### **Knox County Procurement Division Addendum III to Invitation for Bid 3503 Farragut High School Roof Replacement**

**Addendum Date: January 31, 2024**

**Farragut High School Roof Replacement  
Knox County Schools  
Bid #3503  
MBI #231315**

To: Prime contractors and all others to whom drawings and specifications have been issued. This Addendum forms part of the Contract Documents. It supplements and modifies them as follows:

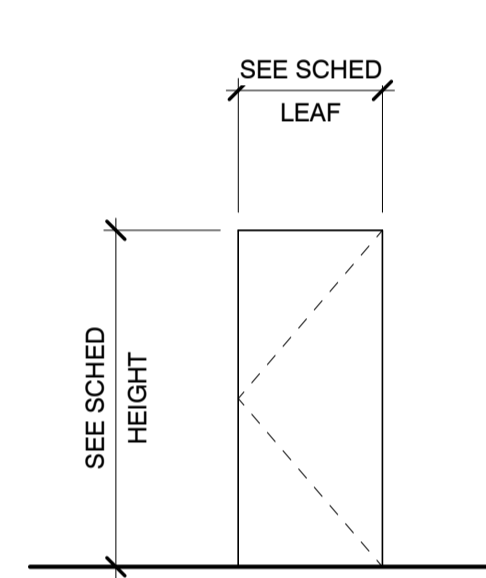
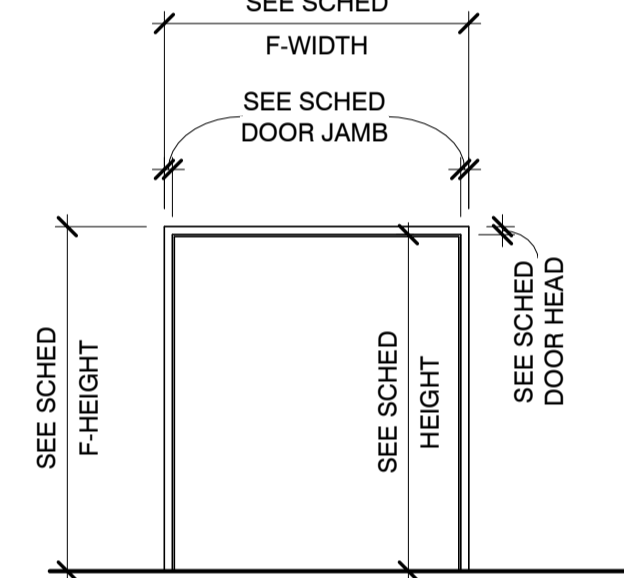
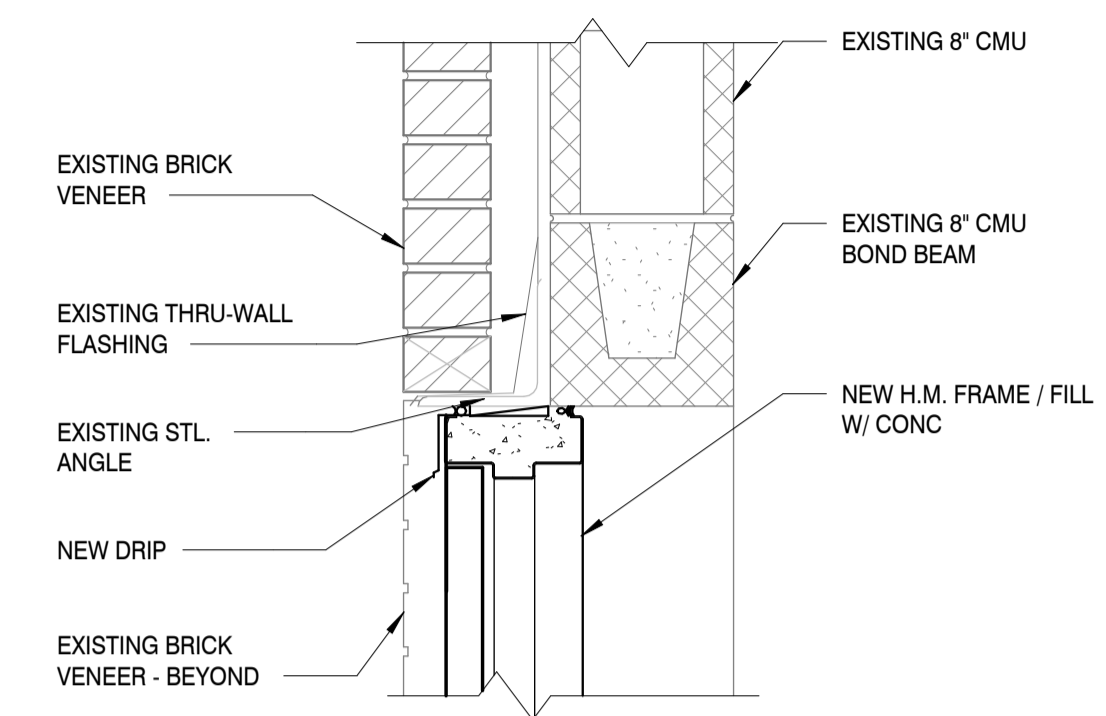
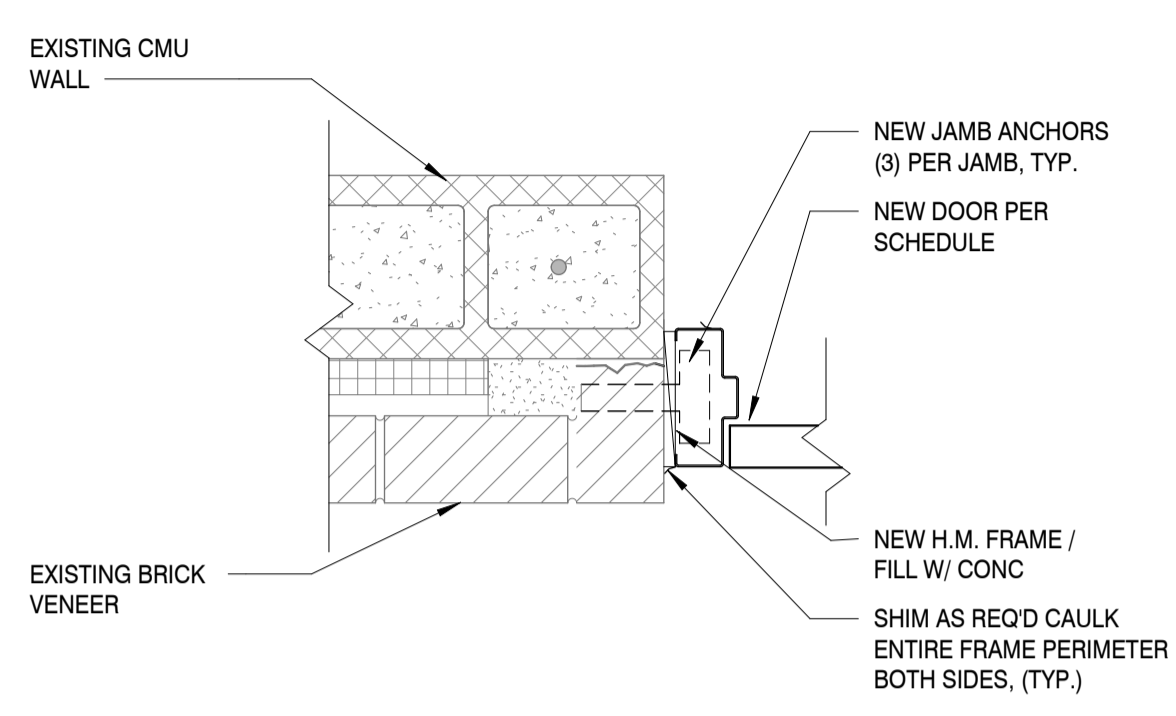
1. New door details sheet A802, see attached drawings.
1. See revised specifications 00 42 13 Bid Envelope Cover, 07 53 23 EPDM Roofing - Fully Adhered, 08 11 13 Hollow Metal Doors and Frames, and 08 71 00 Door Hardware.
